UNITED STATES PATENT AND TRADEMARK OFFICE

09/970,015

Office Action Summary	Application No. 09/970,015	Applicant(s) VEGLIANTE ET AL.	
	Examiner Isaac N. Hamilton	Art Unit 3724

Diagram 1. Figure 3 in Lucas.

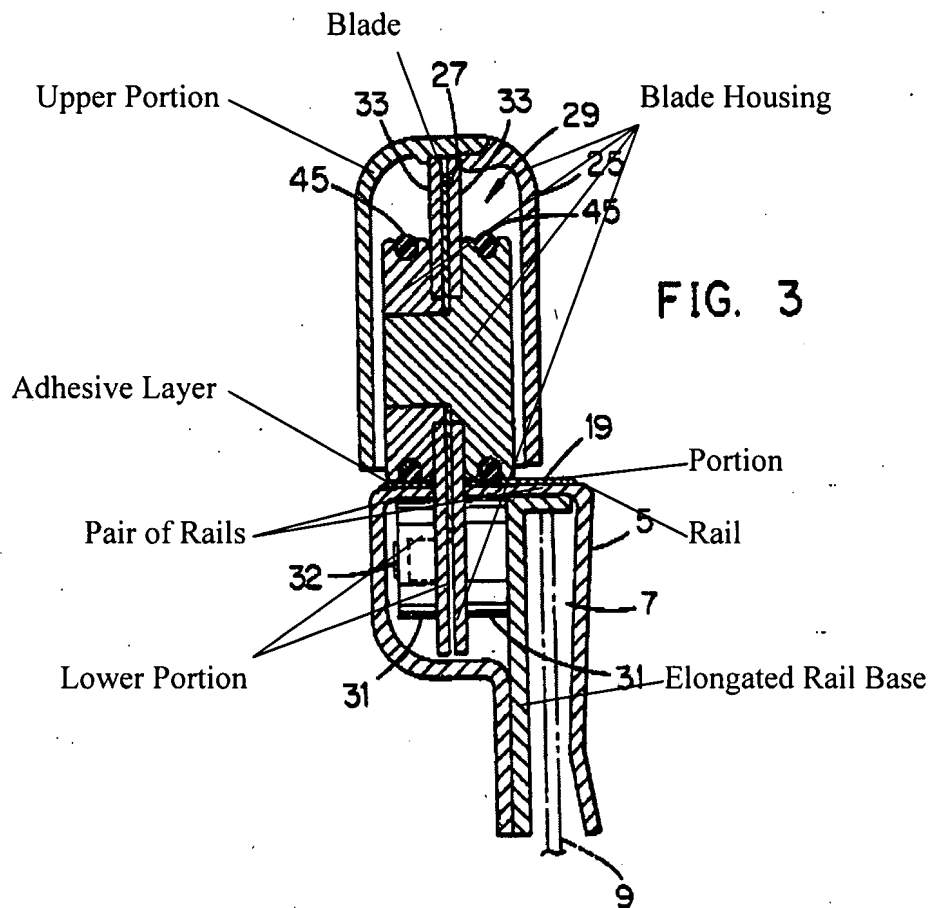
4. Claims 1, 5, 11-17, 20-23, 40, 42, 43 and 44 are rejected under 35 U.S.C. 103(a) as being unpatentable over Lucas, Jr. et al (5,440,961), hereafter Lucas, in view of Wankow (3,549,066). Lucas discloses everything as noted in Diagram 1; channel 13; bottom edge of upper portion of blade housing protrudes on either side of blade in figure 2; end surface of upper portion is rounded and inclined upward as shown in figure 2; tracking device 34; tubular base 31; channel has tubular shape as shown in figure 3; left section 39; right section 35; rivet 37; aperture 51; blade angled from bottom edge at 30 degree angle as shown in figure 2; depression 7; rear edge 5; cover of a carton 9; a material which provides an attraction to the plastic wrap in column 3, lines 6-8.

5. Claims 18 and 19 are rejected under 35 U.S.C. 103(a) as being unpatentable over the combination of Lucas and Wankow as applied to claims 1, 5, 11-17, 20-23, 40 and 44 above, and further in view of Keene et al (3,277,760), hereafter Keene. Lucas discloses channel 13; pair of rails, upper section and lower section shown in Diagram 1 below. Lucas does not disclose a protrusion and does not disclose a blade housing that snap fits into a protrusion. However, Keene teaches protrusion 18, 29, 40, and discloses blade housing 40 that snap fits into the protrusion. It would have been obvious to provide a blade housing that snap fits into a protrusion in Lucas as taught by Keene in order to prevent the blade housing from sliding out of the elongated rail base.
